Meeting Notes

Project 2007-06 System Protection Coordination Standard Drafting Team

August 27-29, 2013

The Project 2007-06 Drafting Team thanks all commenters who submitted comments on the PRC-027-1 standard for System Protection Coordination. The standard was posted for a 30-day formal comment period from June 4, 2013 through July 3, 2013. Stakeholders were asked to provide feedback on the standard and associated documents through a special electronic comment form. There were 67 sets of responses, including comments from approximately 196 different people from approximately 130 companies representing all 10 of the Industry Segments as shown in the table on the following pages.

Figure 1

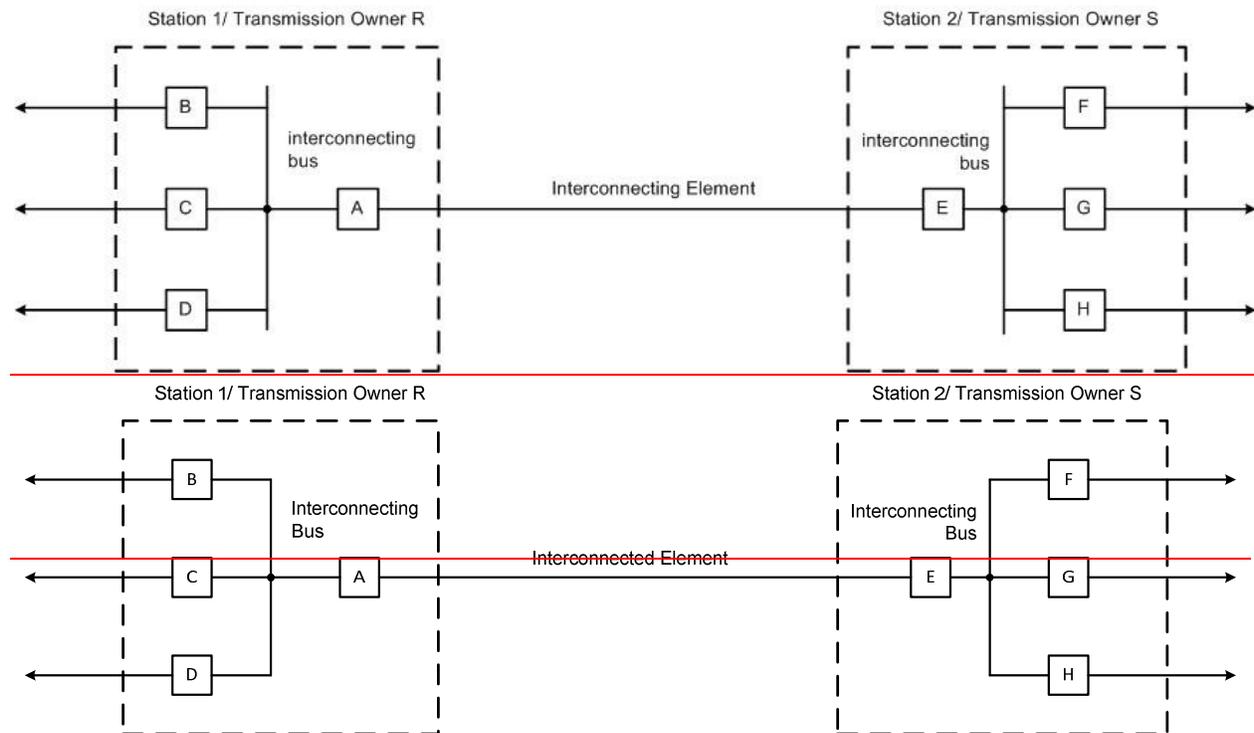
Idaho Power Co.	<p>Thank you for the opportunity to comment. While we are in favor of this version, we seek clarification on one item. Requirement R2 states that the fault values used in determining the 10% change will be measured at the ?interconnecting bus?. While reviewing the examples in the application guideline section, two ?interconnecting bus? are labeled in Figure 1, 3, and 4. If the coordination concern is related to the interconnecting element, it would seem reasonable that the ?interconnecting bus? for Owner S to place faults on to determine the 10% change is that at Station 1/Transmission owner R, looking at figure 1. This would capture the change in fault current seen by the Owner S Protection System on breaker E. Placing faults on the interconnecting bus behind breaker E if I am owner S does not seem appropriate when considering coordination on the interconnecting element.</p>

<p>Response: Thank you for your comment. In reference to Figure 1, the intent is for each Transmission Owner to check for changes in Fault current at its own interconnecting bus; if either owner identifies a 10% change, it would notify the other owner pursuant to Requirement R2, Part 2.2.1.</p>
CenterPoint Energy	<p>The draft for PRC-027-1 states: ?records collected for Reliability Standard PRC-004 do not indicate that lack of coordination was the predominate root cause of reported Misoperations.? CenterPoint Energy considers the proposed requirements to be too</p>

Figure 3

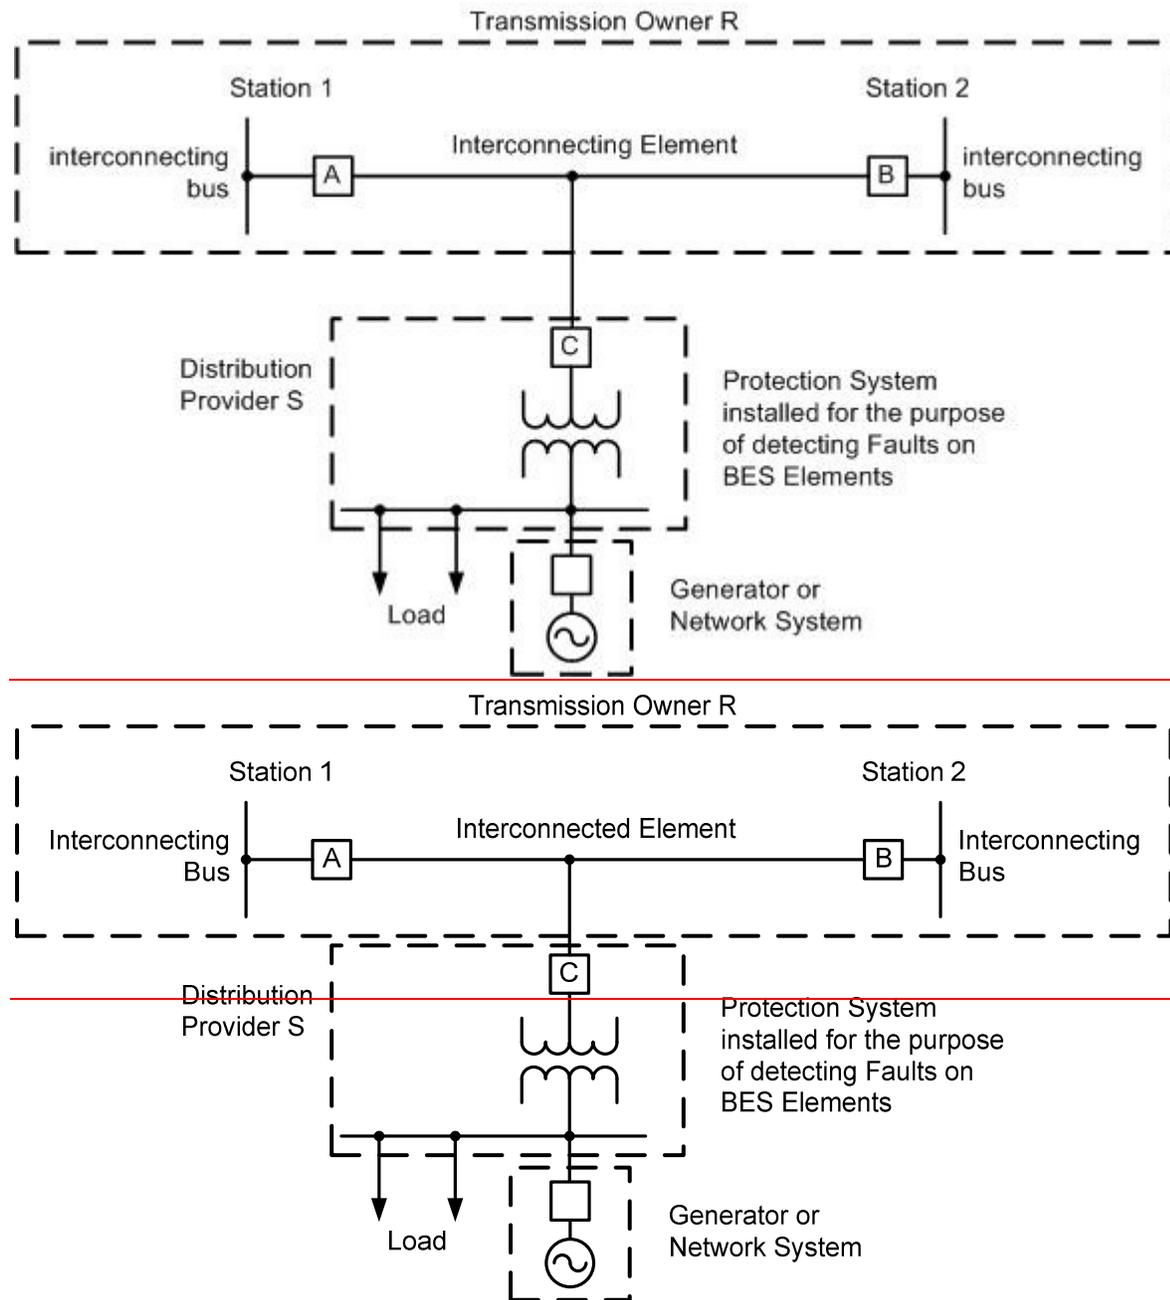
Organization	Question 8 Comment
	<ol style="list-style-type: none"> 2. Also, IMEA requests that Figure 3 be modified or a separate figure be included to clarify guidelines for DP systems that include only non-BES generation. 3. IMEA also requests that Applicability Section 4.2.1 be revised to prevent inconsistency with the FERC-approved interpretation of transmission Protection System as specified in PRC-005-1b. Very specific attention/consideration needs to be given to avoiding unnecessary expansion of applicability to facilities owned by small Distribution Providers; i.e., unnecessary expansion of scope to protective devices owned by a DP that have no potential adverse impact on the BES. Both FERC and NERC have stated the need to minimize impacts on small entity resources.
<p>Response: Thank you for your comment.</p> <ol style="list-style-type: none"> 1. Please see the response to SERC EC Protection and Control Subcommittee (SERC RRO). 2. If a DPs system includes only non-BES generation, and the associated Protection Systems are not installed for the purpose of detecting Faults on Interconnecting Elements of the BES, this standard would not apply to coordination of those Protection Systems. Whether or not the generator in Figure 3 is BES or not does not determine the Distribution Provider’s applicability to this standard; the qualifier is whether or not the associated Protection Systems are installed for the purpose of detecting Faults on Interconnecting Elements of the BES. 3. The term “transmission Protection System”, to which the interpretation you reference applies, is not used in the Applicability section (or within any other portion) of PRC-027-1. Therefore, the draft standard contains no inconsistencies with the FERC-approved interpretation, which was issued to clarify the use of the term in reliability standards PRC-005-1b and PRC-004-2a. Per the Applicability section of PRC-027, the standard only applies to the Protection Systems owned by a TO, GO, or DP that are “installed for the purpose of detecting Faults on Interconnecting Elements of the BES and that require coordination for isolating those faulted Elements”.

SERC RRO	<p>Please change Figures 3 and 4 so that "Interconnected Element" is adjacent or points to the line between Breaker C and the point of connection (tap point) on the line between Breakers A and B. It clarifies these examples by having the Figures align with your wording. (The Figures presently imply that the line between Breakers A and B is the "Interconnected Element?")The comments expressed herein represent a consensus of the views of the above-named members of the SERC EC Protection and Control Subcommittee only and should not be construed as the position of SERC Reliability Corporation, its board, or its officers.</p>
<p>Response: Thank you for your comment. The drafting team revised Figures 3 and 4 to indicate the tap line is the Interconnecting</p>

Figures 3 and 4 were revised to indicate the tap line is the Interconnecting Element.

Figure 4

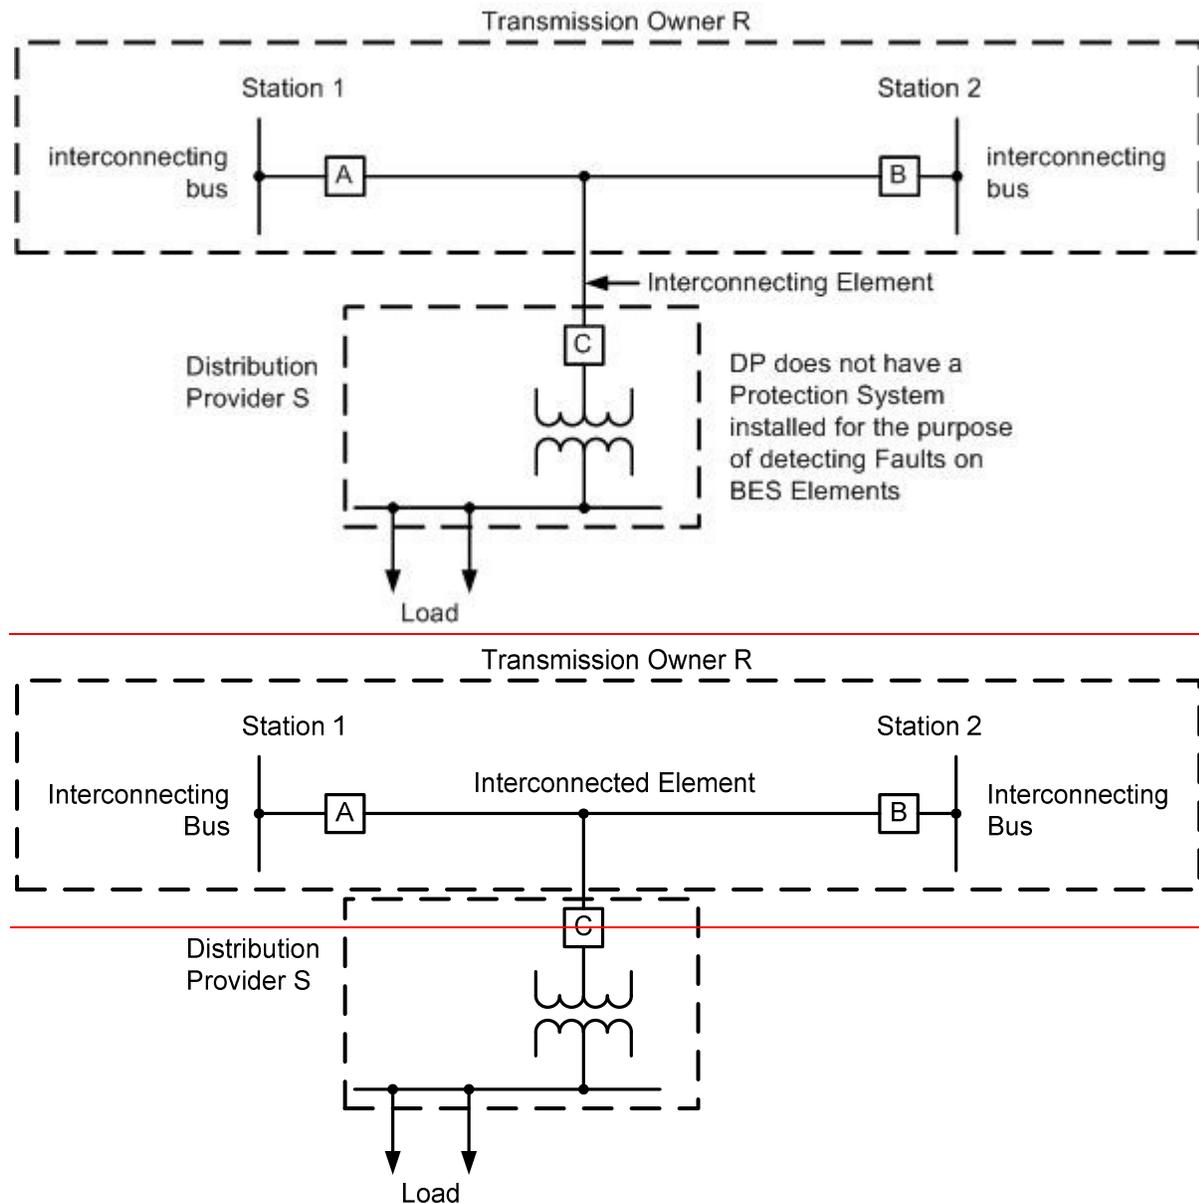
Organization	Yes or No	Question 2 Comment
		<p>this fact and Figure 4 should be corrected. If the intention is that Figure 4 should be an Interconnected Element so that R2 still applies, then clarification that Interconnected Elements does not require Applicability section 4.2 defined facilities is required.</p> <p>2. ITC Holdings engineers perform coordination at Interconnected Elements between ITC Holdings subsidiaries ITCTransmission and METC, both registered TOs. The definition should exclude applications such as this, where the only outcome is increased administrative burden to be auditable with no reliability benefit to BES.</p>
<p>Response: Thank you for your comment.</p> <ol style="list-style-type: none"> The drafting team revised Figures 3 and 4 and the associated texts for clarity. The drafting team disagrees with your premise. The drafting team intends for this standard to address coordination of Protection Systems installed for the purpose of detecting Faults on Interconnecting Elements, and that require coordination for isolating those faulted Elements - between separate Registered Entities or between separate functional entities within the same Registered Entity. For the case where two registered entities with the same protection group are doing all the coordination, the drafting team included the following note: "In cases where a single group performs an overall coordination study for a given Interconnecting Element; a single document that provides the requirements for a summary of the results of the PSCS would be sufficient for use by all entities."

Organization	Question 8 Comment
	<p>Element must be revised to exclude Figure 4 example, or Figure 4 must be corrected to show TO is still responsible for R1-R4.</p> <ol style="list-style-type: none"> 3. Example Figures 1-5 create responsibilities on owners to ?propose? and ?review for coordination? which are not found in the standard. Either these responsibilities should be removed from Figures or the responsibilities should be added to the standard. 4. The last sentence in Figure 5 specifies the TO will provide GO settings to the other TO. This contradicts R3 which states, ?Each TO, GO, and DP shall provide to each TO, GO, and DP?? <p>Again, the Figures are creating responsibilities not found in the standard.</p> <ol style="list-style-type: none"> 5. The purpose of Applicability section 4.2 Facilities is unclear. Each requirement deals with requirements around the Interconnected Elements. If the purpose of section 4.2 is to try and exclude DP relays which do not purposefully trip for BES faults, this should be more clearly stated. This exclusion should be moved to Interconnected Element definition and section 4.2 rewritten to target Interconnected Elements. Or section 4.2 should be the corrected Interconnected Element definition, and there will be no need for a new definition in this standard. 6. Example Figure 2 creates different responsibilities for GO than Figure 3 does for DP. Why the difference? Essentially they are the same: both have protection systems which trip for faults on Interconnected Element. Again, the Figures are creating responsibilities not found in the standard.

<p>Response: Thank you for your comment.</p> <ol style="list-style-type: none"> 1. The drafting team believes that the draft standard provides a reliability benefit of ensuring that all existing, modified, or new Protection Systems on Interconnecting Elements are coordinated for proper performance during Faults. The drafting team believes that this standard is necessary to codify the roles and responsibilities of the interconnecting owners to achieve coordination of Protection Systems that affect the reliability of the BES. 2. The drafting team modified Figure 4 to address your concern.

Figure 5

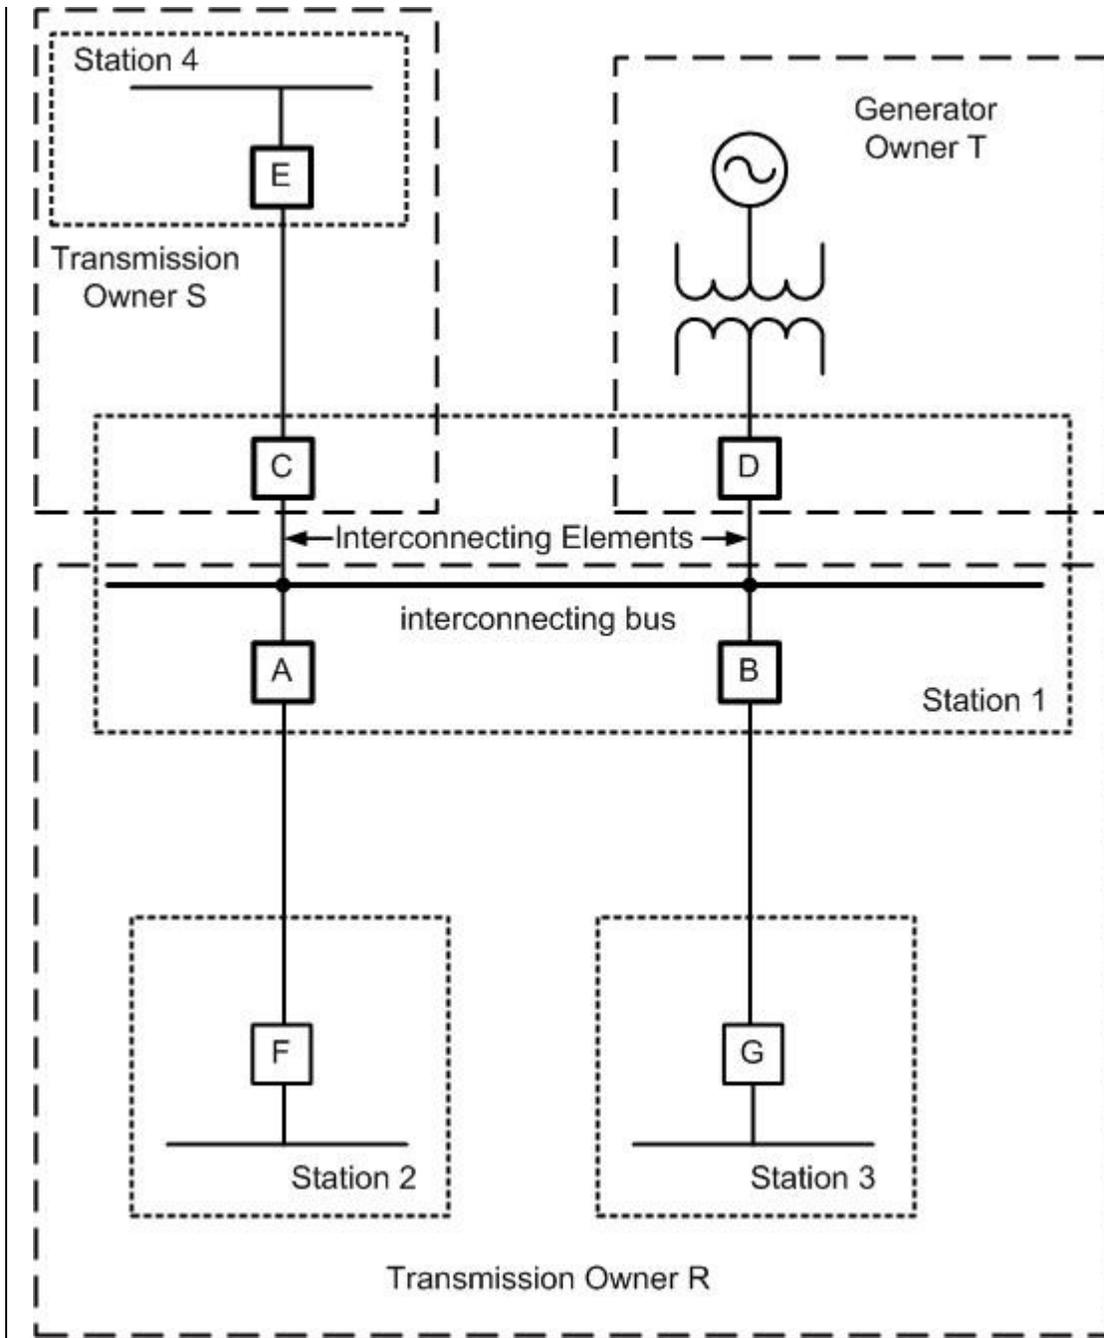
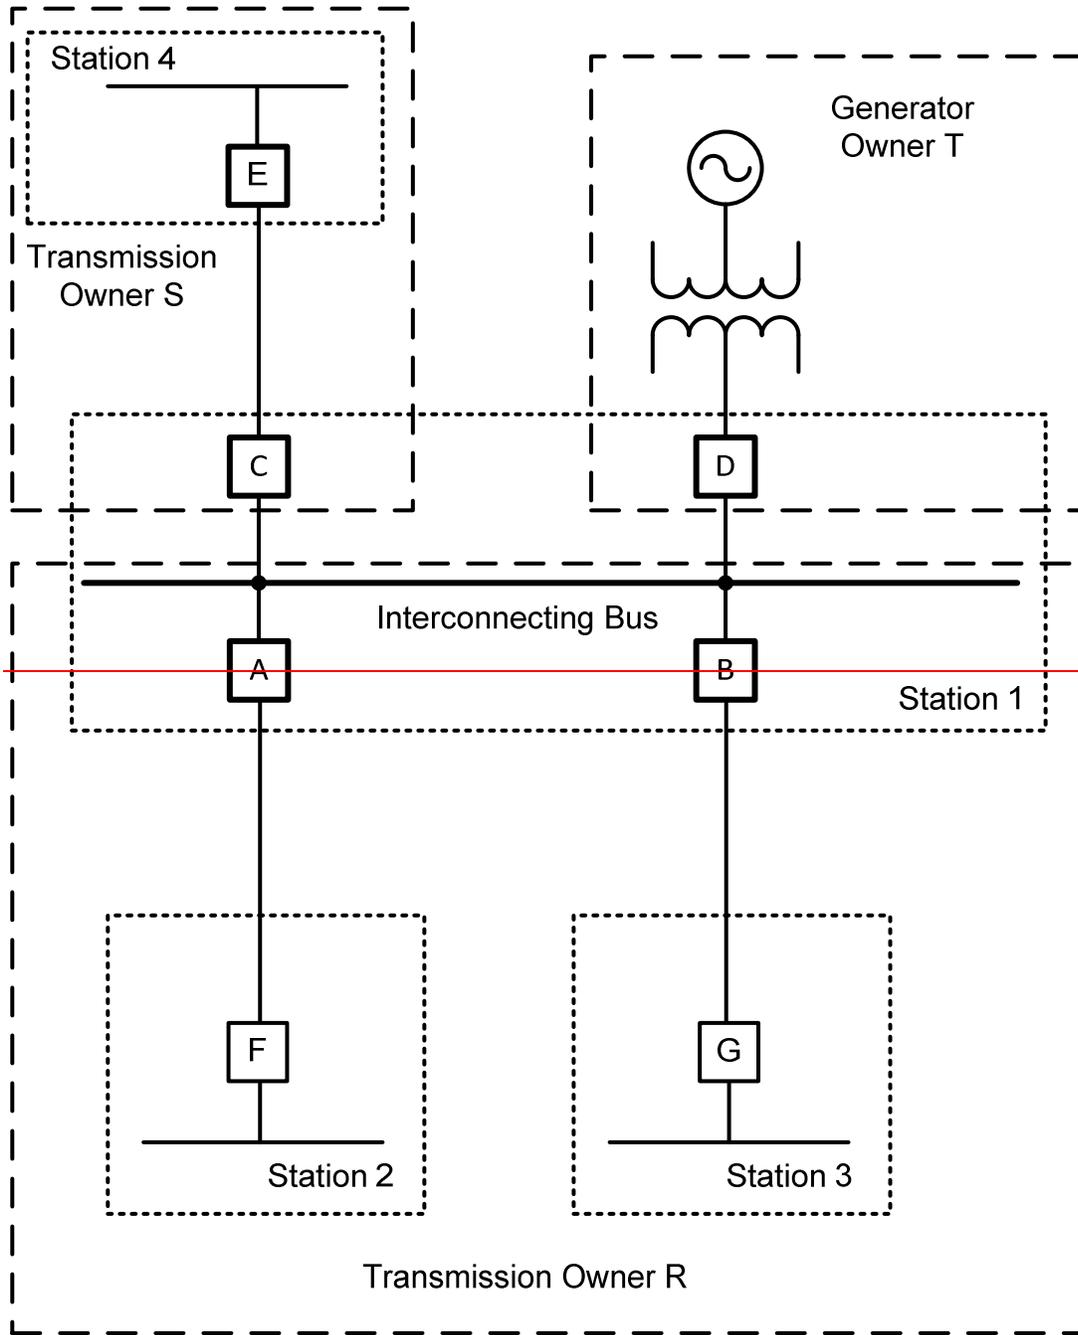
Organization	Question 8 Comment
Element.	
American Electric Power	<ol style="list-style-type: none"> 1. PRC-001-3: R1 ? The term ?protection system? should be capitalized to match previous versions of this standard. 2. PRC-027-1: Mapping Document ? The verbiage in R1.1 of the mapping document does not match the wording in the proposed standard: ?Protection System Study? is used instead of ?PSCS?. 3. PRC-027-1: Figure 2 ? The phrase ?generator Protection Systems? is often used by Generation Owner relay engineers to mean the Protection Systems installed for the purpose of detecting faults on and protecting the physical generator, which is clearly outside of the scope of this standard. Therefore, AEP recommends changing the verbiage associated with this figure to remove the phrase ?generator Protection Systems? and replace it with a reference to Generator Owner R?s Protection Systems installed for the purpose of detecting faults on the Interconnected Elements. Suggested wording is shown below: <p style="margin-left: 40px;">Transmission Owner S is to review the Protection System settings associated with Breaker A *and the Interconnected Element* (provided by Owner R) for coordination issues with the Protection System settings associated with Breakers C, D, E, and F. Likewise, Owner S is to develop proposed Protection System settings associated with Breaker C. Generation Owner R is to review the Protection System settings associated with Breaker C *and the Interconnected Element* (provided by Owner S) for coordination issues with the Protection System settings associated with Breaker A.</p> 4. PRC-027-1: R3 & Figure 5 ? As written, R3 will place undue burden on each TO, GO and DP to maintain a list of all other entities connected to each interconnecting bus to which they connect. Furthermore, since the elements are typically owned by the TO, burden will be placed on the TO to respond to requests from other TO?s, GO?s and DP?s as they build their list. R3 and its? associated Figure 5 should be revised such that the responsibility lies with the
